Consultation Response from KC, Highways Development Management (HDM)		
2023/91212 Land off Bankfield Drive, Holmebridge, Holmfirth, HD9 2PH		
Erection of 21 dwellings with access from Laithe Avenue		
Date Responded: 14/10/24	Responding Officer: A.Darwin	Responding Ref: HDC 3-26/3

RECOMMENDATION: No objection, subject to Conditions / S106

The bespoke trip generations have then been distributed on the local highway network utilising existing turning proportions, and assuming all development traffic utilises Bankfield Drive for robustness. These are shown on Figure 106 that has been extracted from the RSA Brief below:

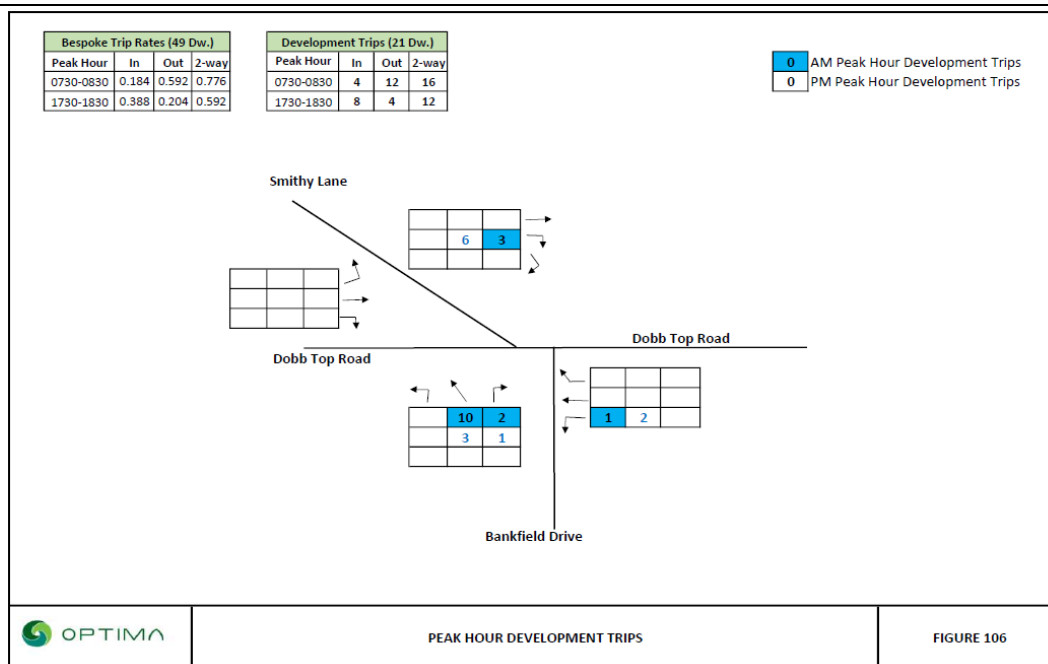
HDM accept the above development trip assessment assumptions, and agree that the identified development trips and distribution derived from the bespoke trip rates provides a robust basis for assessment.
